ADDENDUM 4

FOR: CENTRAL HOUSE AND GARDEN
606 East Central, Bentonville, AR

October 23, 2026

ADDENDUM 04

E304

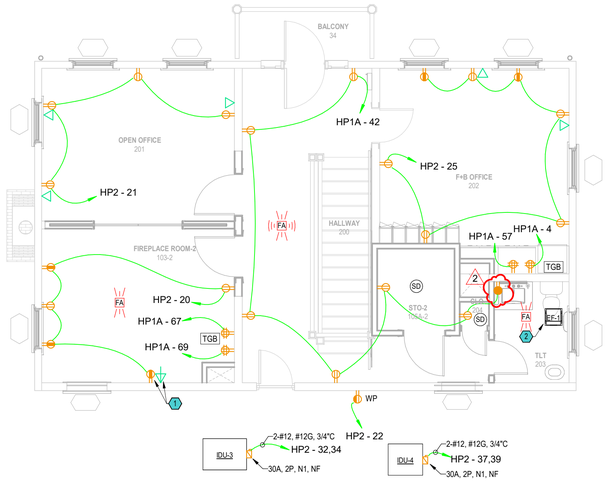
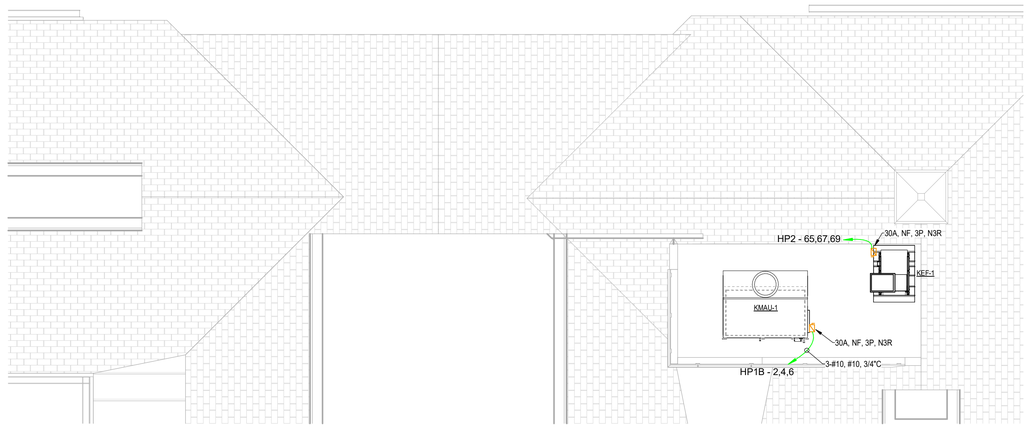
3. Refer to Revised Sheet 303 – FIRST FLOOR PLAN – POWER – revision dated 10/23/26:

SHEET NUMBER
M402

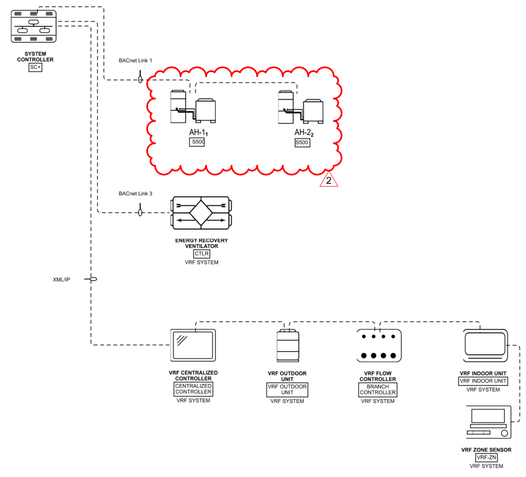
2. Refer to Revised Sheet M402 – SCHEDULES – HVAC – revision dated 10/23/26:

A. Adjusted Air Device schedule with clarifying remarks.

P301

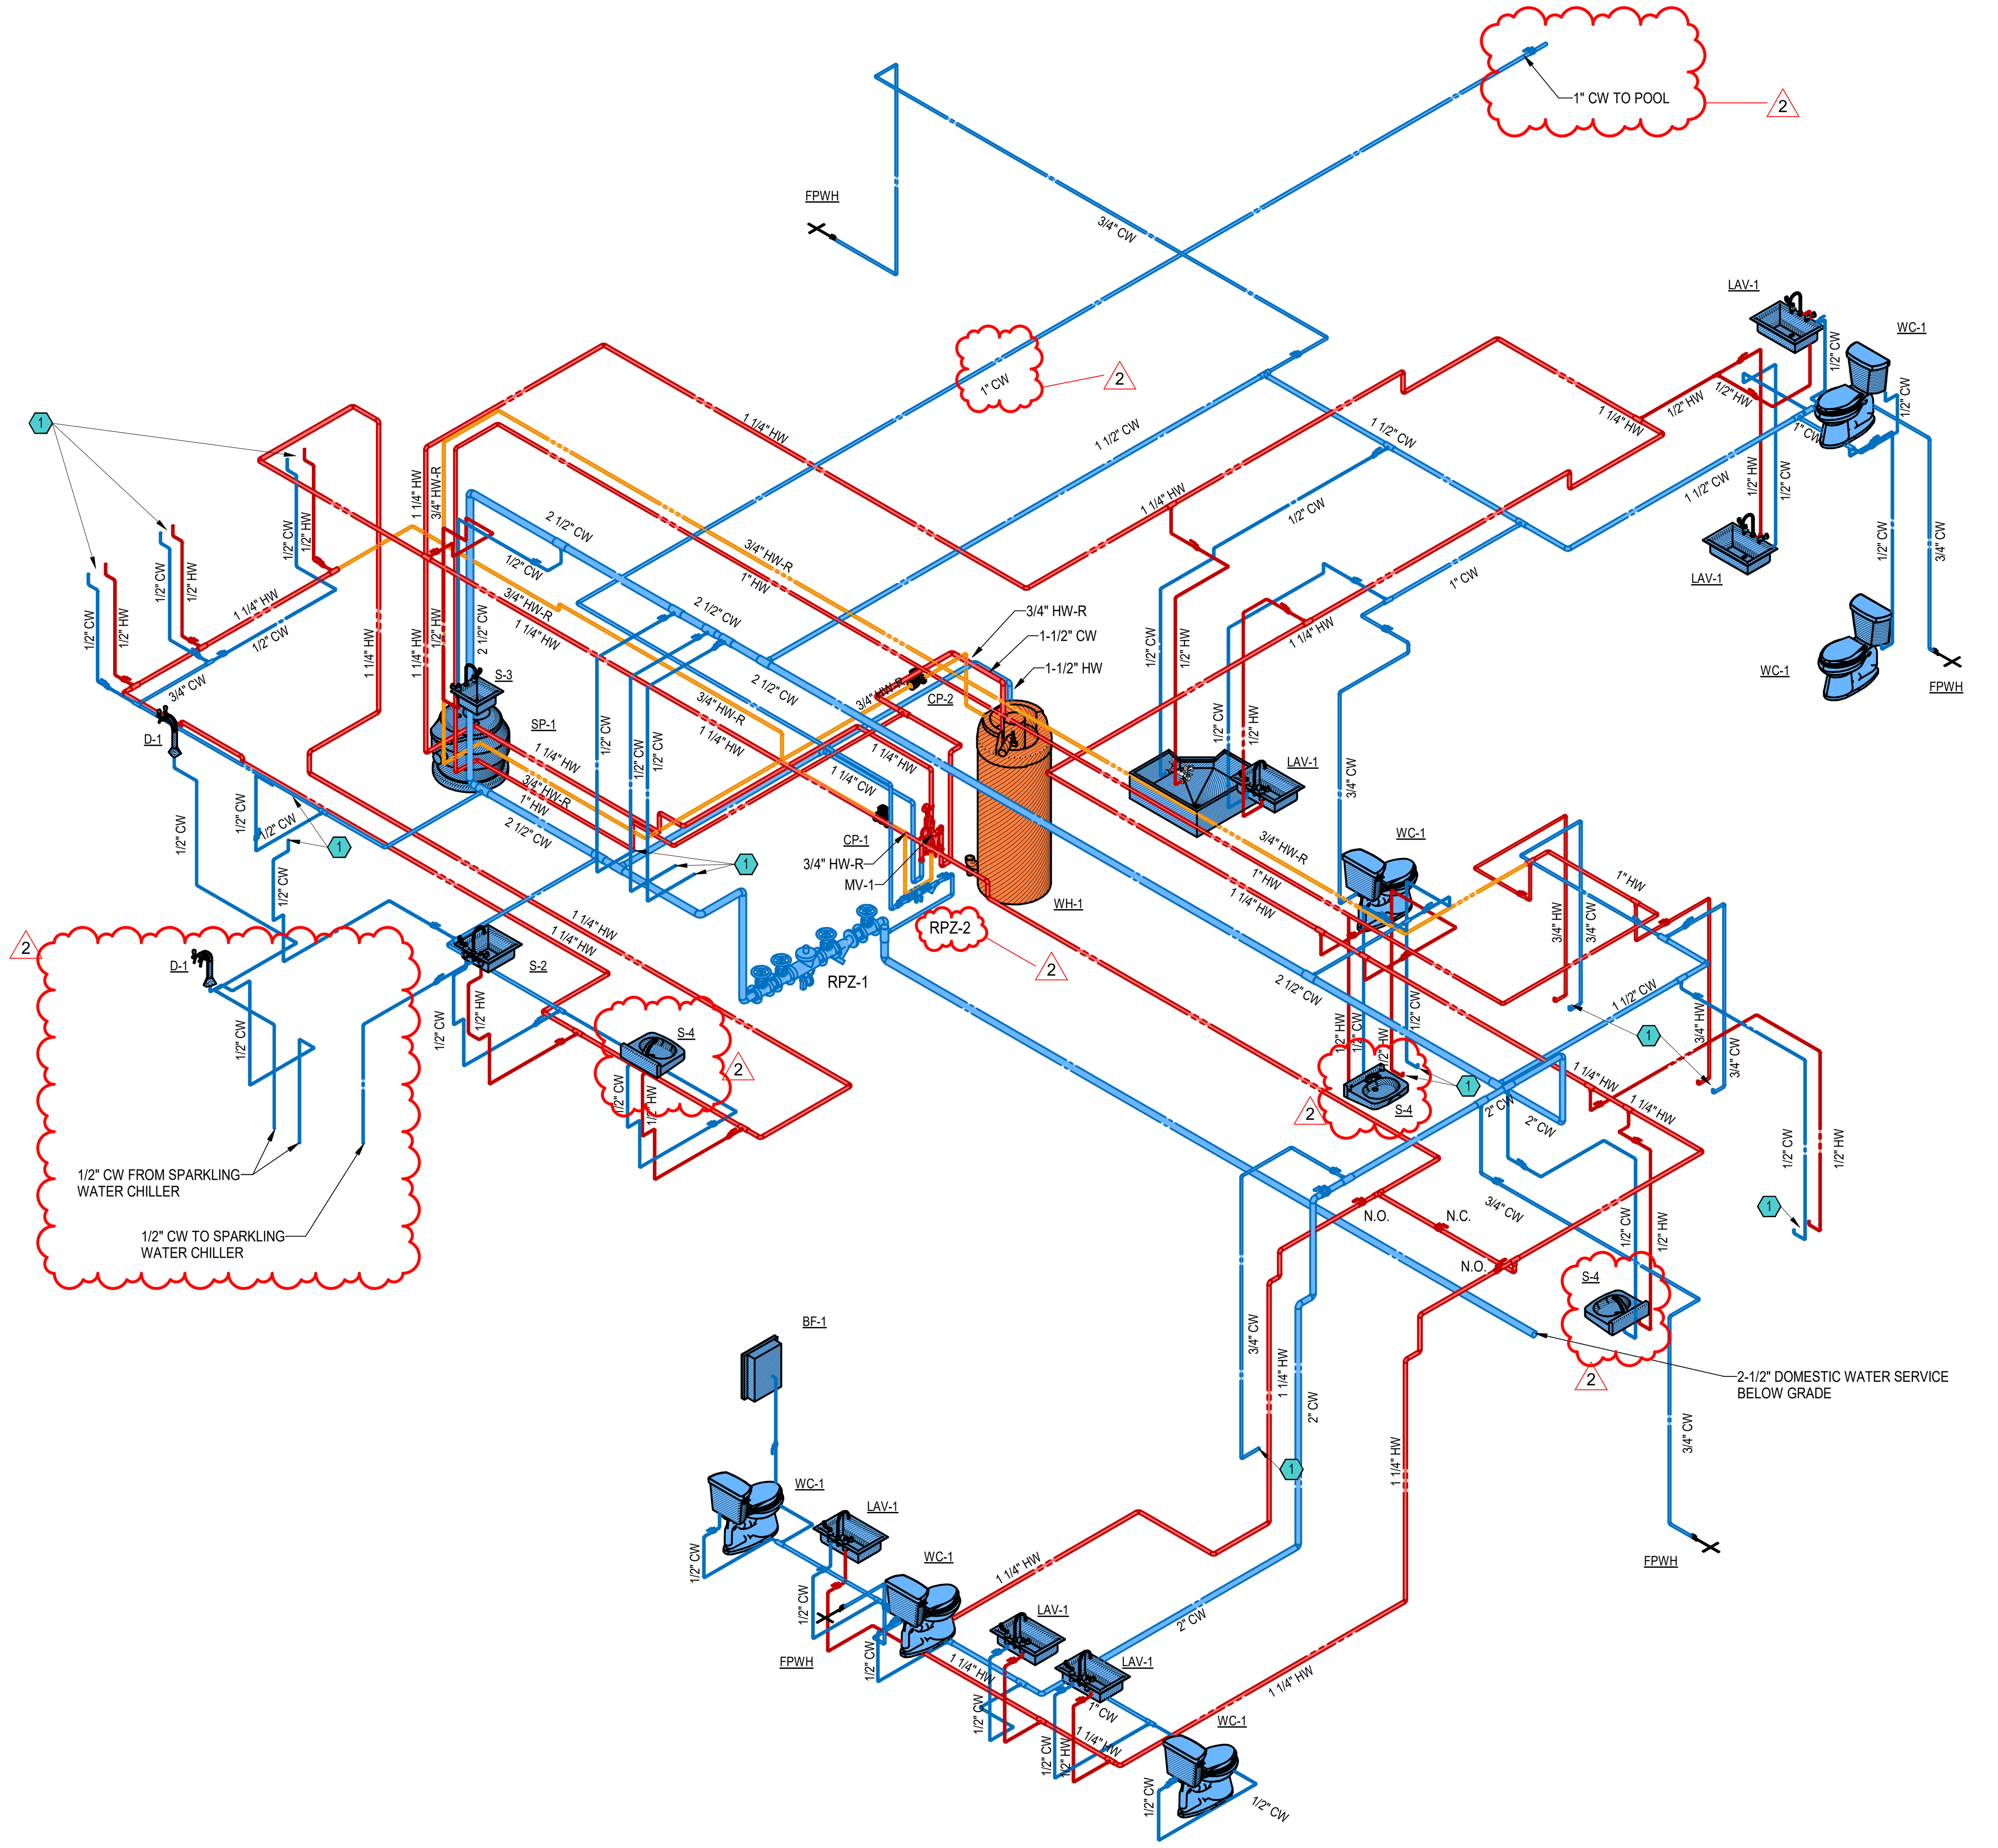
4. Refer to Revised Sheet P301 – RISER DIAGRAMS - PLUMBING – revision dated 10/23/26:

A. Add (3) S-4 handwash sinks in kitchen area.

1 PLUMBING RISER DIAGRAM - DOMESTIC WATER
NOT TO SCALE:

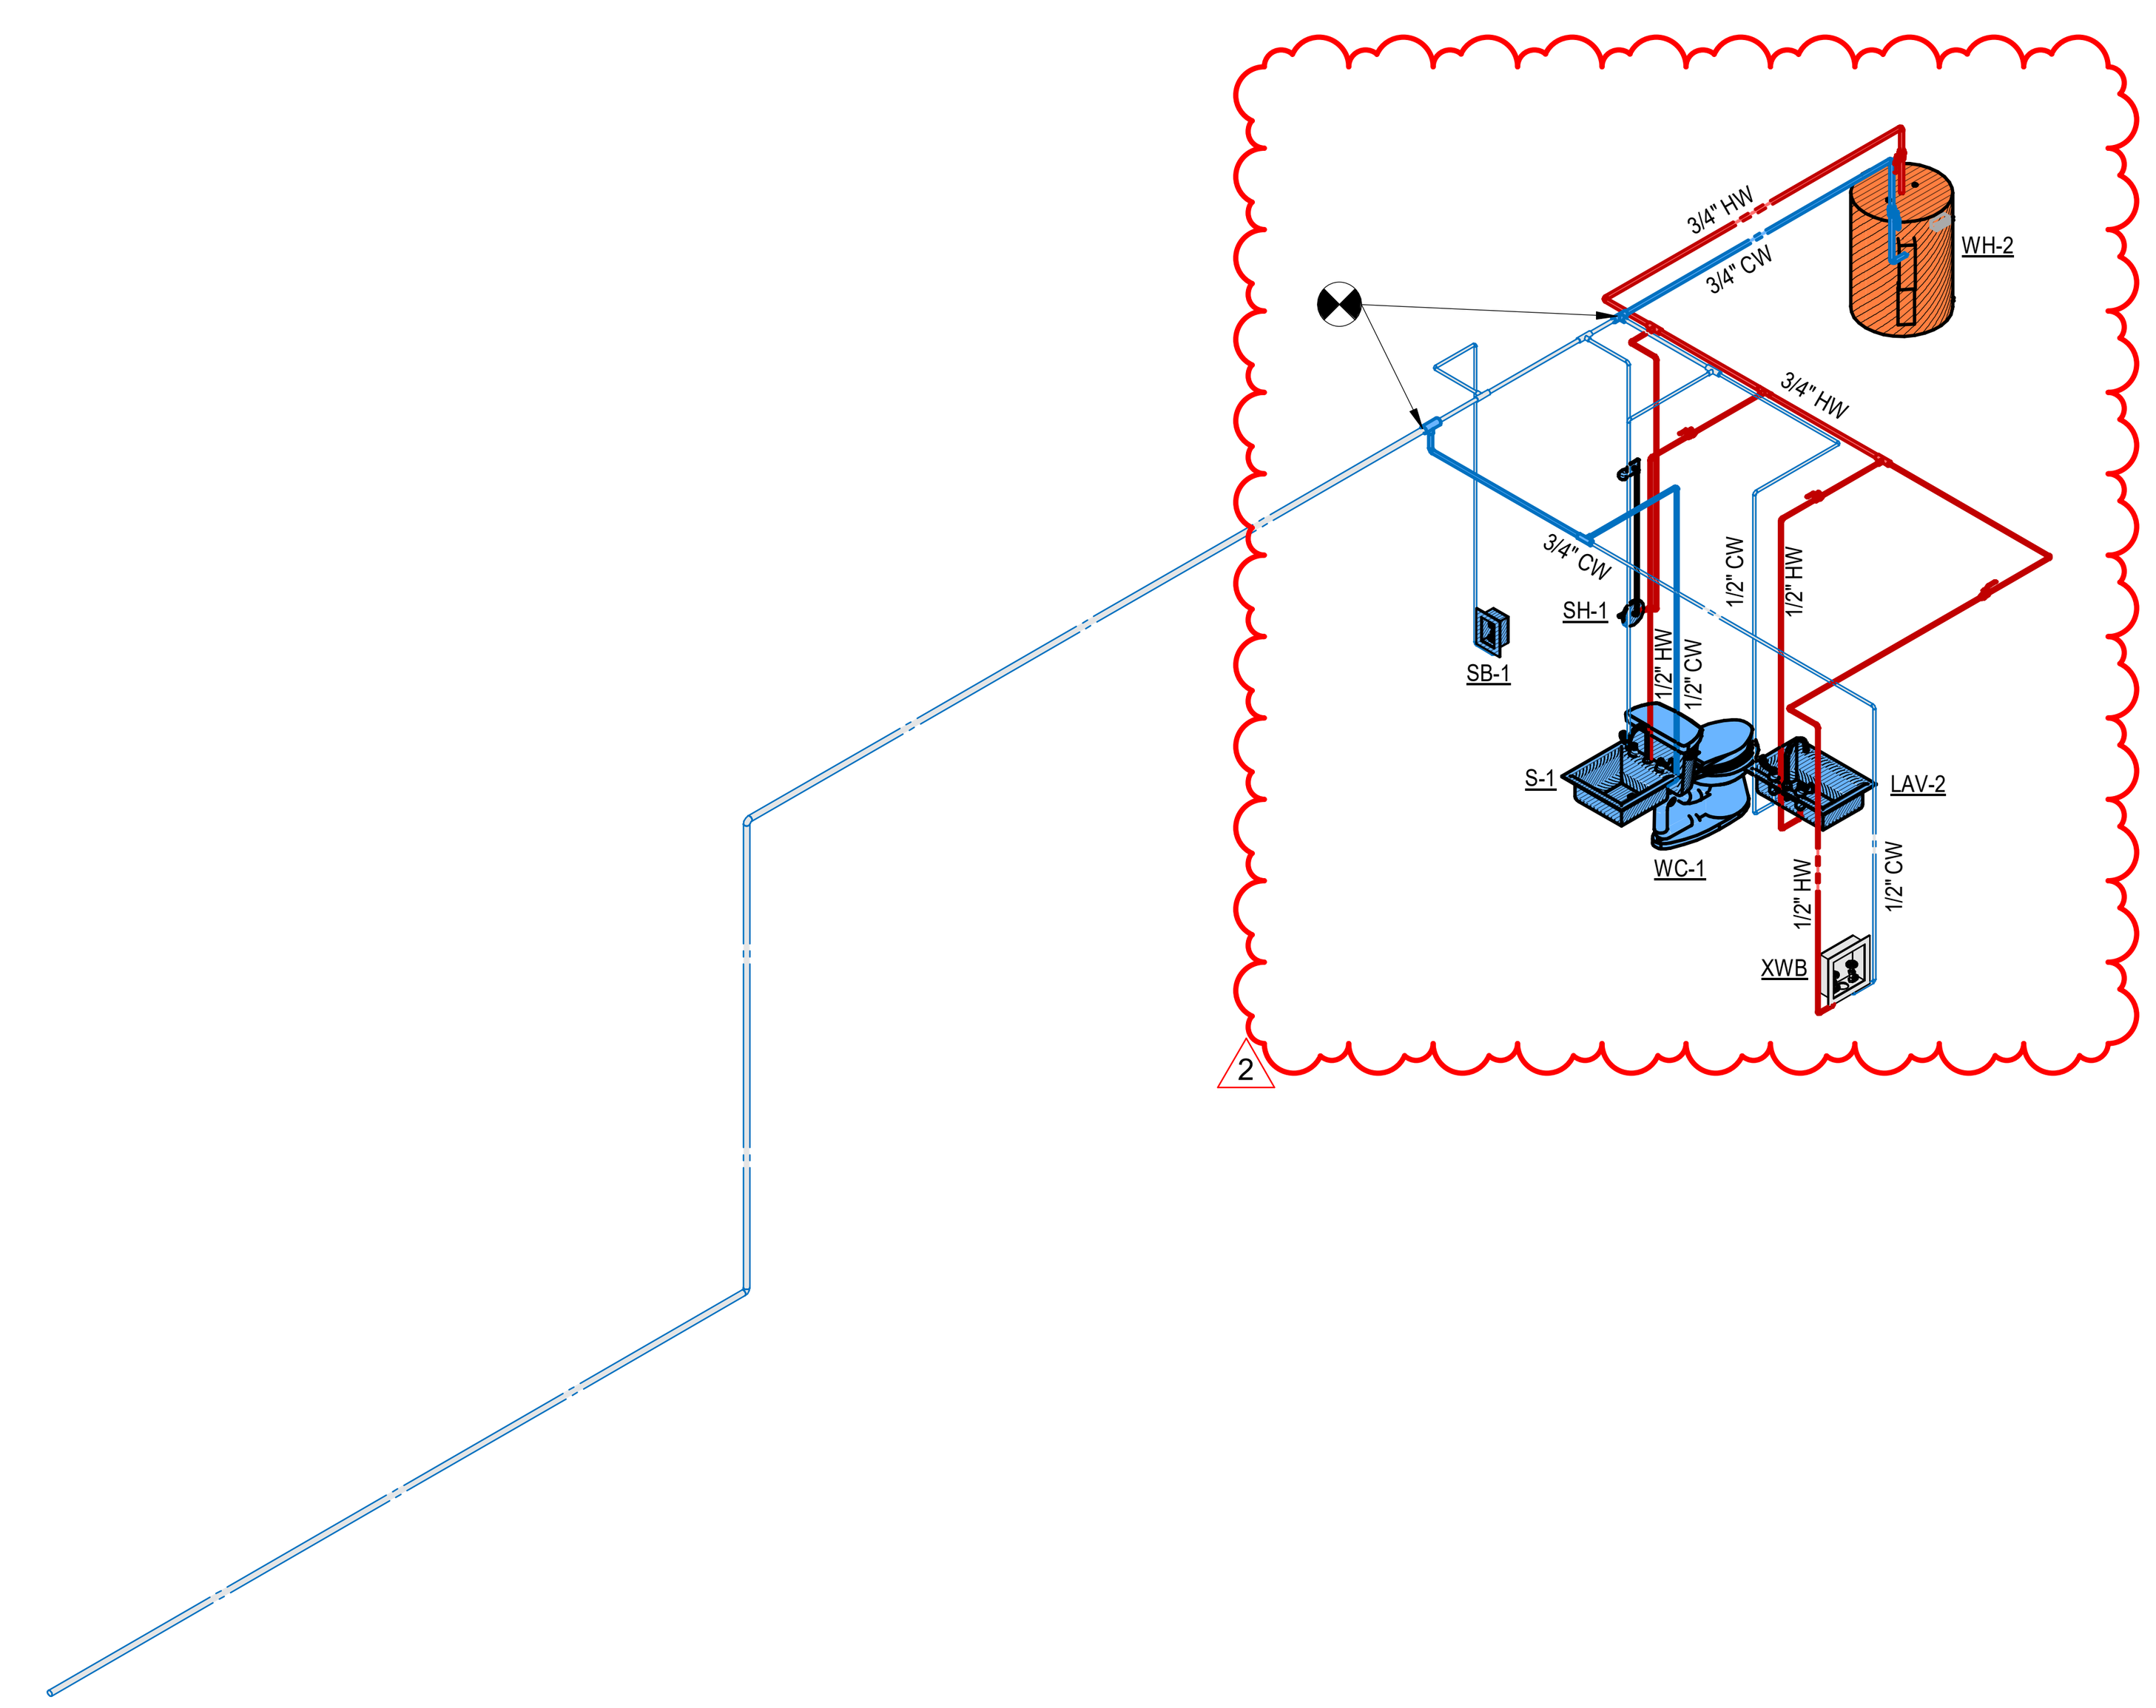
5. Refer to Revised Sheet P302 – RISER DIAGRAMS - PLUMBING – revision dated 10/23/26:

A. Add (3) S-4 handwash sinks in kitchen area to detail 1.
   B. Add sparkling water chiller notes to detail 1 for clarity.
   C. Revise location of water heater in detail 2.
   D. Revise RPZ-2 and water line serving pool to 1".
   E. Add valve to 1" line serving pool.

P501

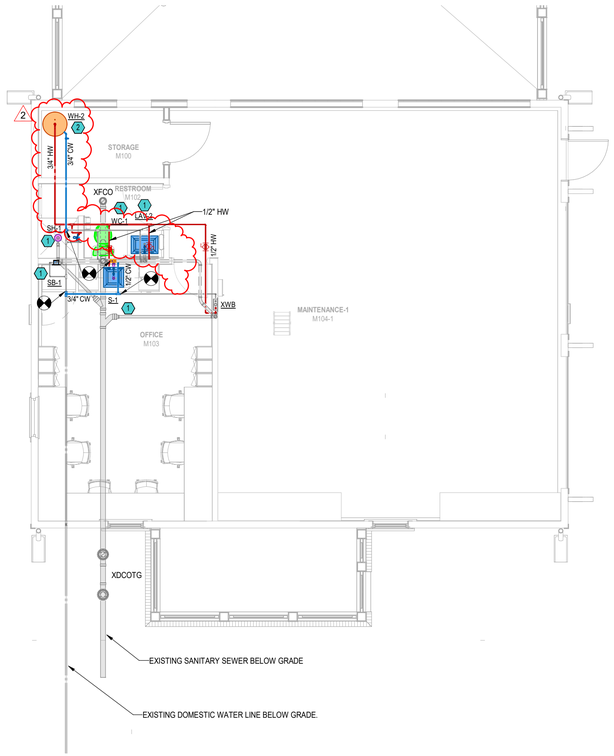
6. Refer to Revised Sheet P501 – SCHEDULES - PLUMBING – revision dated 10/23/26:

A. Revise S-3 on Plumbing Fixture Schedule.
   B. Add S-4 to Plumbing Fixture Schedule.
   C. Revise RPZ-2 on Plumbing Specialties Schedule.
